SUPERSEDES
3570A-3

-hp- Model 3570A Network Analyzer

REPLACEMENT PARTS CHANGES

Figure 1. Modified Mixer/IF Amplifier

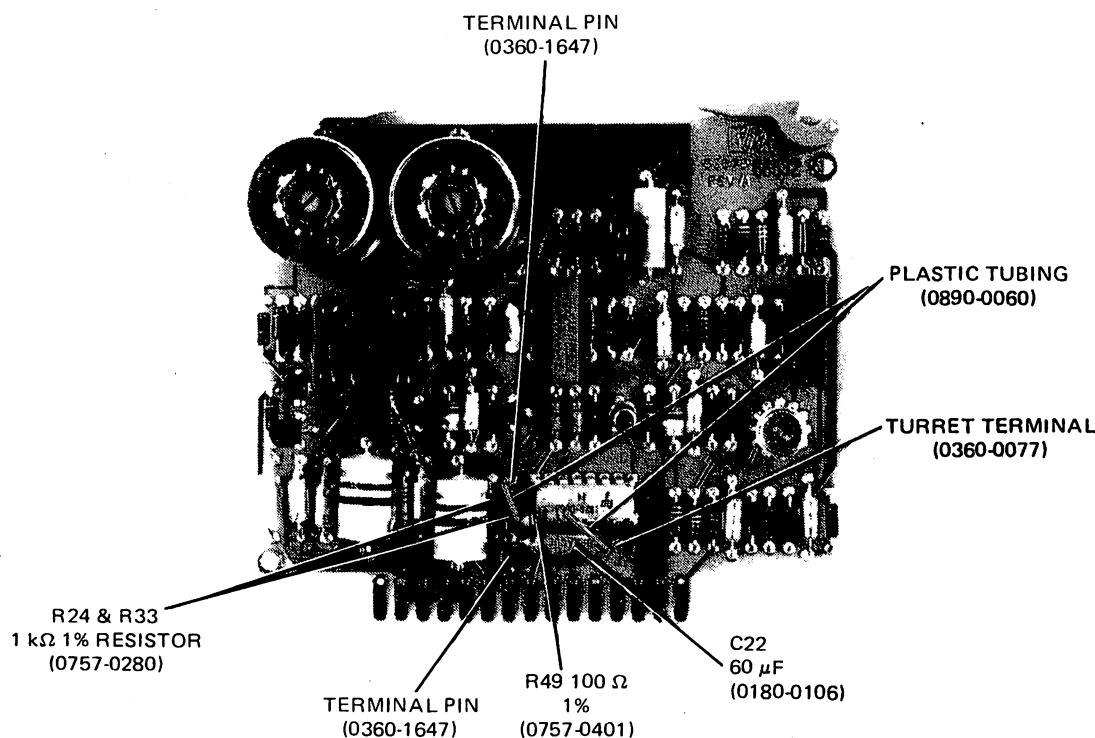
If you replace the old style A1/A7 Input Amplifiers of your 3570A with two new style input Amplifier Boards (03570-66551, 50 ohms, or 03570-66558, 75 ohms), you must modify the existing A2 and A18 Mixer/IF Amplifier Boards. Any Rev. B Mixer/IF Amplifier Board can be modified by simply changing A2/A18R24 and R33 from 75 ohm resistors to 1 kilohm 1% 1/8 watt metal film resistors (-hp- Part No. 0757-0280), and replacing A2/A18R49 (100 ohm 1% metal film resistor, -hp- Part No. 0757-0401). R49 would have been removed per the instructions of the previous paragraph and during a repair replacement of the Mixer/IF Amplifier. Revision A Mixer/IF Amplifier Boards must be modified more extensively.

1. A2/A18R24 should be changed from a 75 ohm resistor to a 1 kilohm 1% 1/8 watt metal film resistor (-hp- Part No. 0757-0280).
2. A2/A18R33 should be removed. Solder a terminal pin (-hp- Part No. 0360-1647) into each of the two holes used by R33 (short end of pin through the board).

3. Connect a 1 kilohm 1% 1/8 watt metal film resistor (-hp- Part No. 0757-0280) between the two terminal pins installed in Step 2.
4. Install a brass turret terminal (-hp- Part No. 0360-0077) approximately 1/4" directly below U2 pin 15. Use a number 51 (.0670") bit to make a hole for the turret. Flange out the bottom of the turret terminal so it is held firmly in the circuit board.

5. Solder a 60 μ F capacitor (-hp- Part No. 0180-0160) between the bottom terminal pin installed in Step 2 (the pin connected to pin 7 of the Mixer&IF Amplifier Board) and the terret terminal installed in Step 4. Cut off any excess lead.

6. Place plastic tubing (-hp- Part No. 0890-0060) on both ends of a 100 ohm 1/8 watt 1% metal film resistor (-hp- Part No. 0757-0401). Solder the resistor between the turret terminal installed in Step 4 and the upper terminal pin installed in Step 2.

7. All Rev. A Mixer/IF Amplifier Boards should now appear as in Figure 1. All Rev. B Mixer/IF Amplifier Boards should be modified as described previously.
